**AGENDA**  
**BIRMINGHAM DESIGN REVIEW BOARD**  
**WEDNESDAY JULY 19, 2023**  
**BIRMINGHAM CITY HALL, 151 MARTIN ST, COMMISSION ROOM 205, BIRMINGHAM MI \***  
**\*\*\*\*\* 7:15 PM\*\*\*\*\***

**DATE:** July 19, 2023  
**TO:** Design Review Board  
**FROM:** Nicholas Dupuis, Planning Director  
**SUBJECT:** 33202 Woodward – Design Review

**DATE:** July 19, 2023  
**TO:** Design Review Board  
**FROM:** Nicholas Dupuis, Planning Director  
**SUBJECT:** 220 Park St. – Design Review

Typical Screenwall Detail  
1/4" = 1'-0"

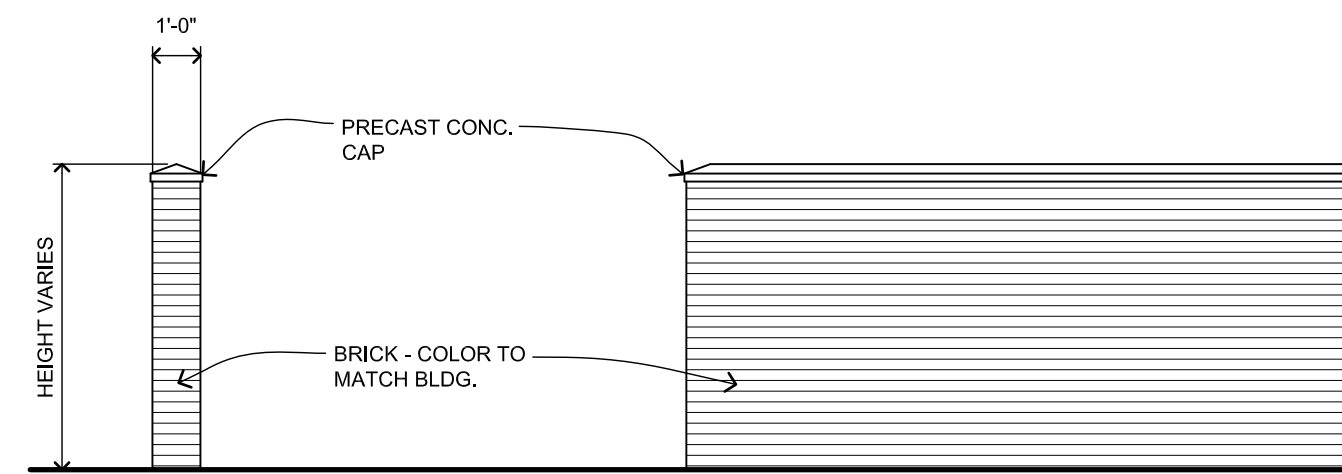
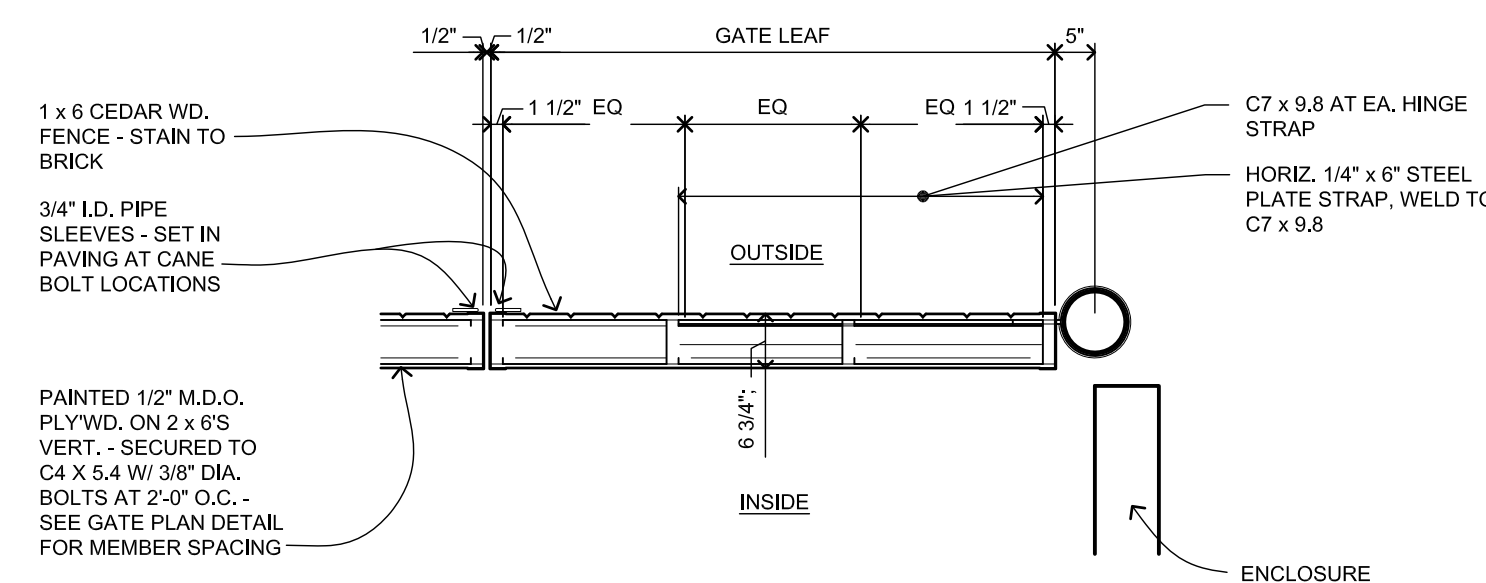
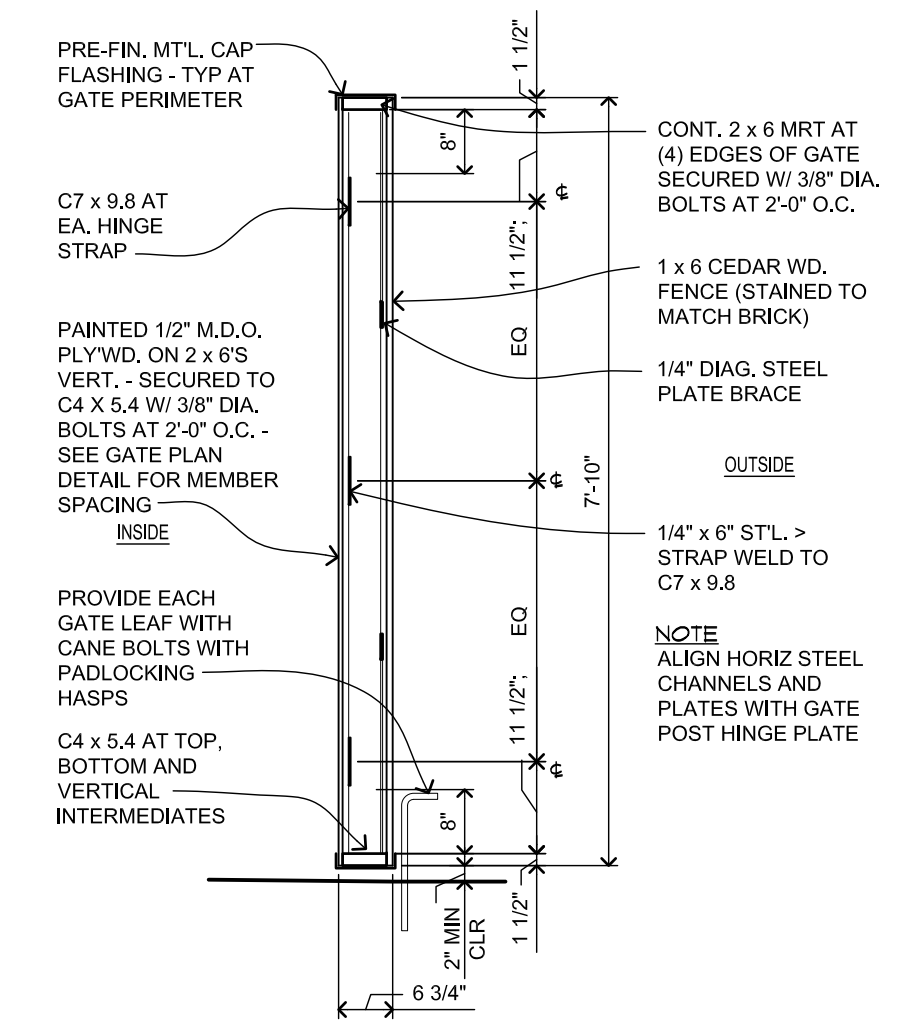
**Screening:** The subject site contains existing screening along most of the off-street parking facilities, and several existing mechanical units and waste receptacles that are both unscreened. At this time, the applicant is proposing to rebuild the parking lot

screenwalls with a 3 ft. capped masonry screenwall as required by Article 4, Section 4.54 of the Zoning Ordinance.

Additionally, the applicant is proposing to build an enclosure for some existing ground-mounted mechanical units. The enclosure will be constructed of capped masonry and wood gates, which meets the requirements of the Zoning Ordinance.

Site Plan

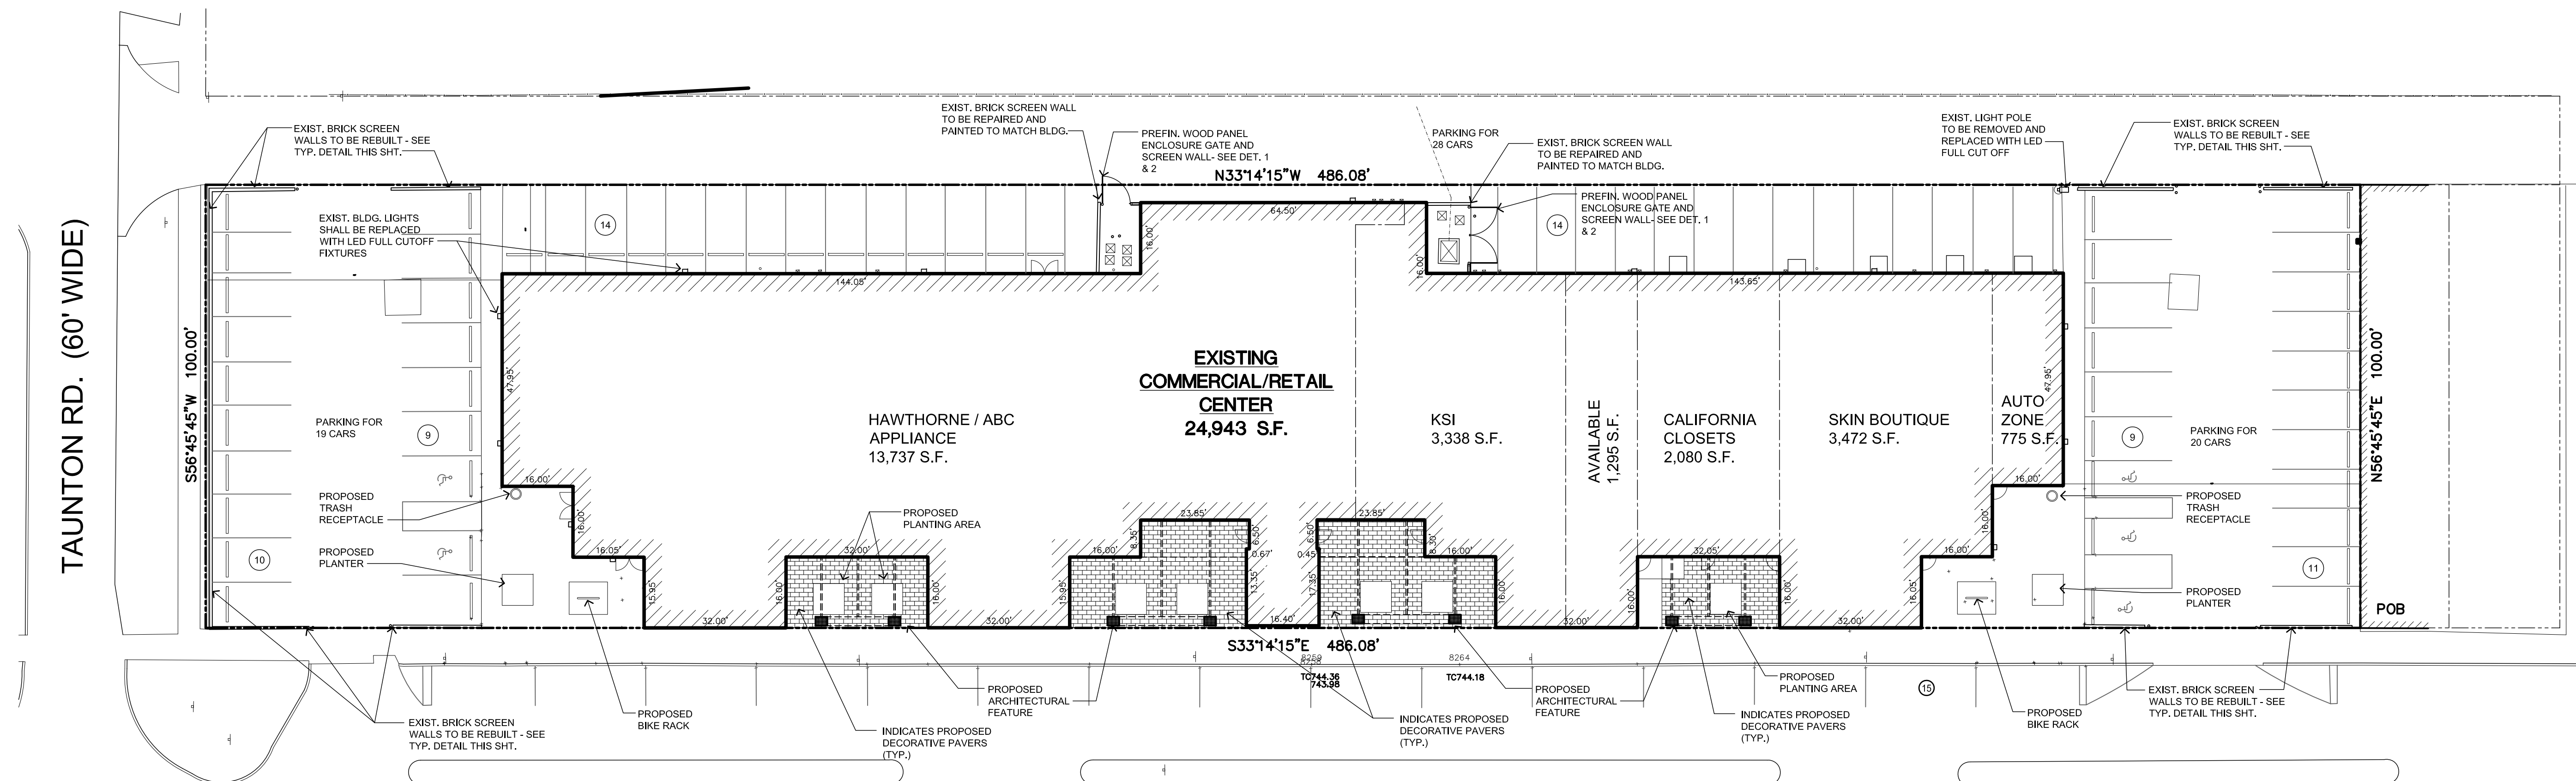
**Parking:** As noted above, there are four separate off-street parking facilities on the site. A review of existing conditions suggests that there are currently about 64 off-street parking spaces to service 24,943 sq. ft. of retail use. The site plans submitted propose a total of 59 off-street parking spaces. Article 4, Table A of the Zoning Ordinance requires retail uses to provide 1 off-street parking space for each 300 sq. ft. of floor area, which would require this site to provide 83 off-street parking spaces. Because the applicant is not proposing to modify the parking facility, they are permitted to maintain the current legal non-conformity.

**Landscaping:** The current site does not contain landscaping. The applicant is proposing to install 9 new landscaping beds along the front property line at the corners and within the coves of the building. Along with landscaping beds, the applicant is proposing to install decorative pavers within the alcoves of the building frontage. The planting types proposed at 63 Dwarf Blue Lavender and 18 Drift rose plantings.

Both planting types are permitted species and will upgrade the visual interest across the site. Board may However, the Design Review wish to require the applicant to diversify the planting types to introduce different textures, heights and colors to add further interest to the proposed landscaping areas.

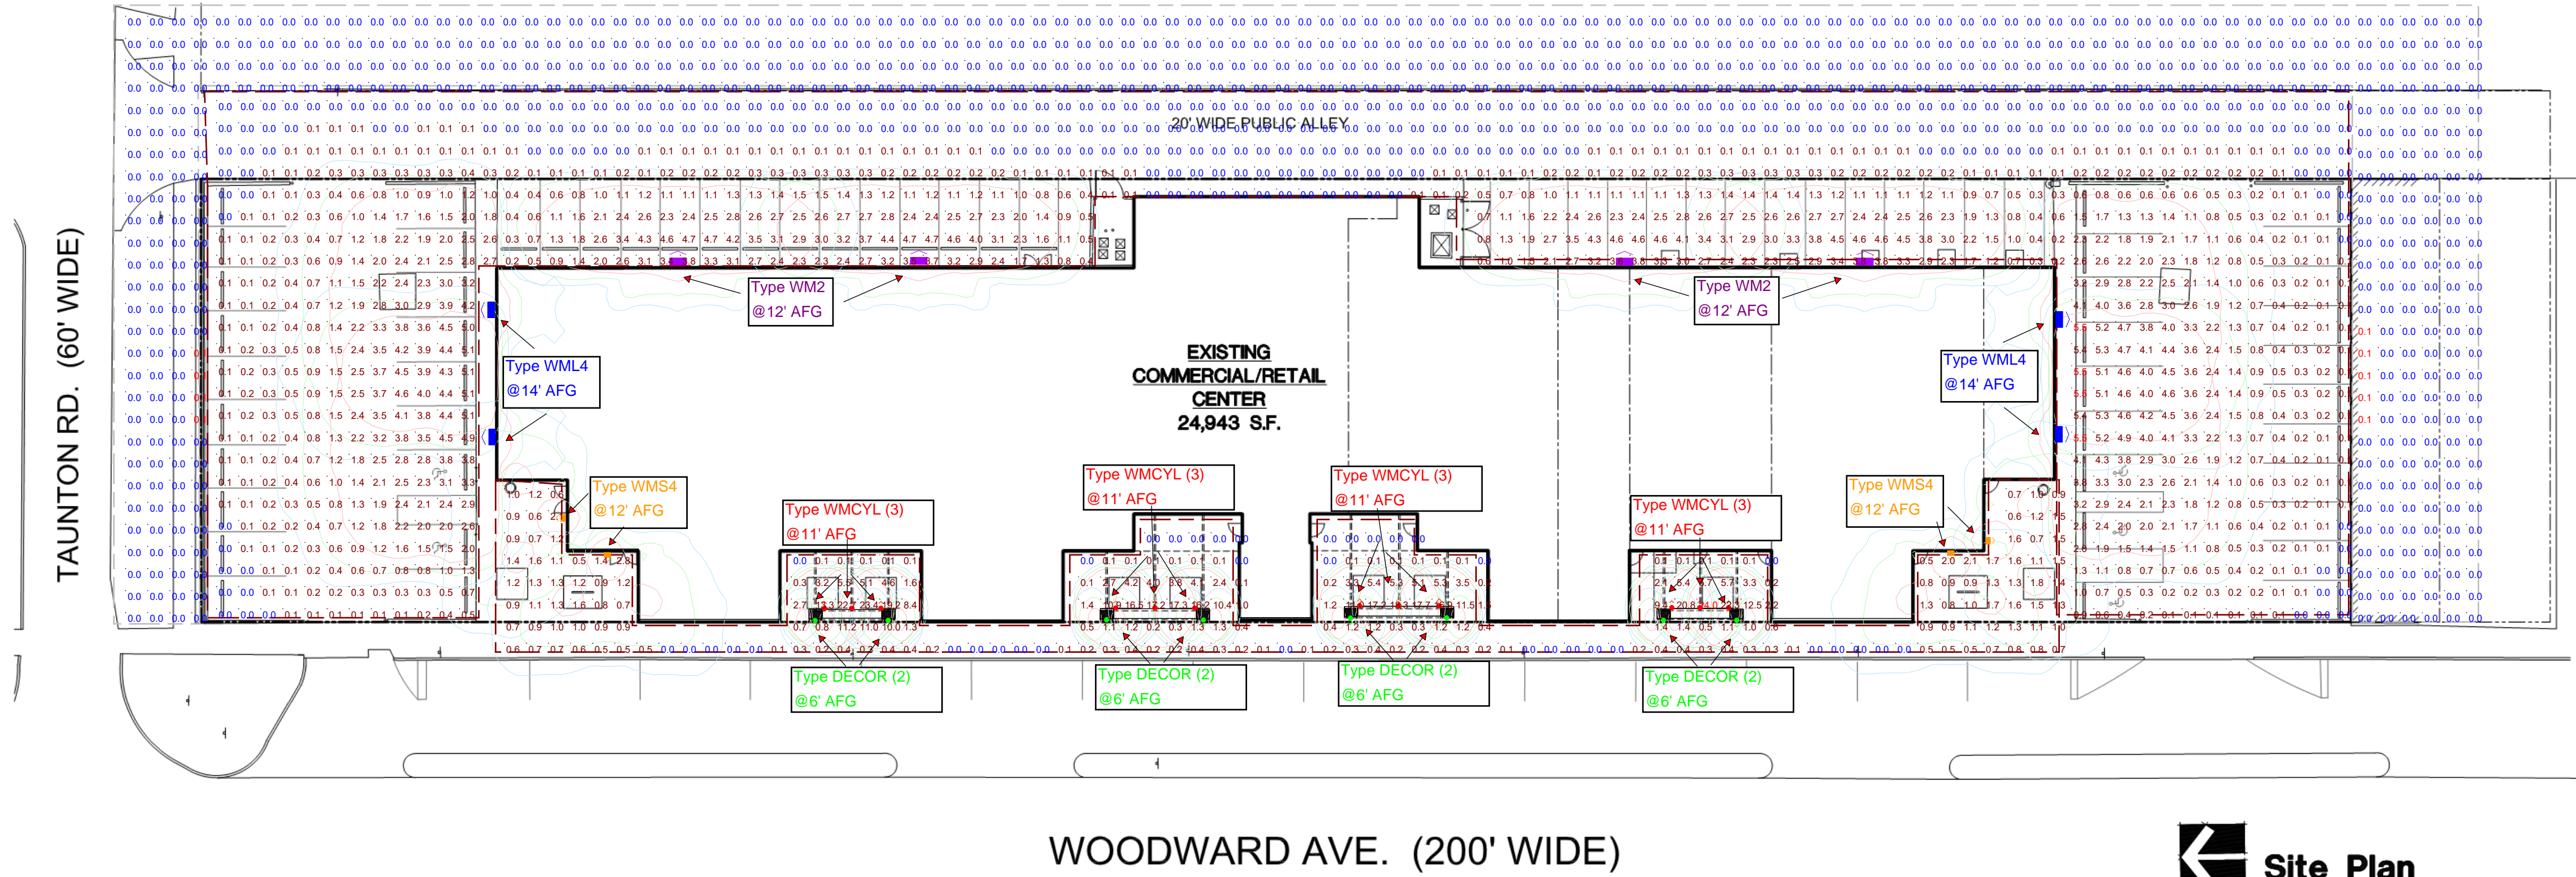
Section 4.21 (E) requires that the intensity of light on a site shall not exceed six-tenths (0.6) maintained foot-candles at any property line that abuts a single-family residential zoned property or one and one half (1.5) maintained foot-candles at any property line for any other zoned property. The subject site contains front and side property lines that abut commercially zoned property, and a rear property line that abuts an alley and single-family zoned district directly beyond. Due to the presence of an alley, the applicant will be required to maintain the commercial light intensity standards as opposed to residential.

As the photometric plan shows, the light levels proposed do NOT exceed the maximum 1.5 maintained foot-candles.
